**ROAD LAYOUT
HOUSING DEVELOPMENT
FROGSTON ROAD (POD B)
EDINBURGH**

STAGE 3 ROAD SAFETY AUDIT
(SPA Ref No: 4282)

Annex 2 PROBLEM LOCATION PLAN

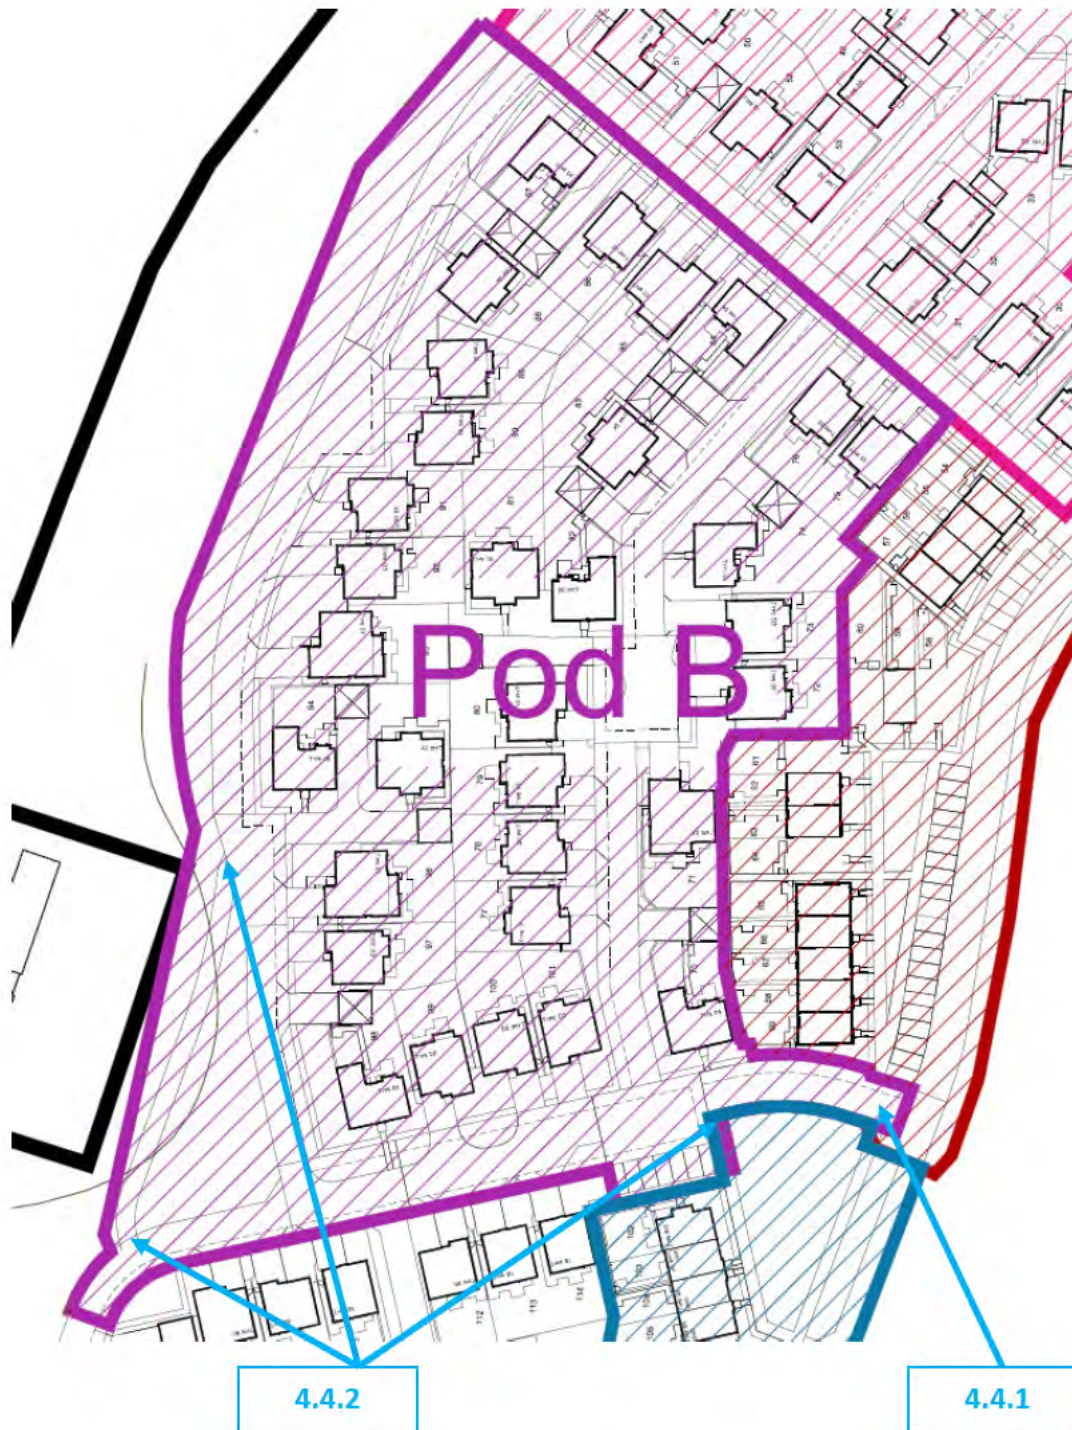
Location: Dunniker Way – East end
Drawing(s): E9876~0925

Summary: Crossing points on desire lines at junctions should ideally match up to help reduce tripping type accidents and improve accessibility.

At the east end of Dunnikier Way the footpath on the north and south of the junction did not tie-in due to being provide in an off-set manner.

Spray paint had been provided to show the potential line of north side footway to provide a crossing point that tied in with the southside footway.

It was however noted that at the existing north side dropped kerb there were a number of services.

The Audit Team would question if it was perhaps more practical to alter the south side footway alignment. Possibly from the lighting column northwards (See image below)

However as both dropped kerbs appeared to be 'high' it may be both sides for the footway will require work.

It is recommended that the proposed snagging works be completed as soon as possible and that the option of altering the south side footway be reviewed by the design team.
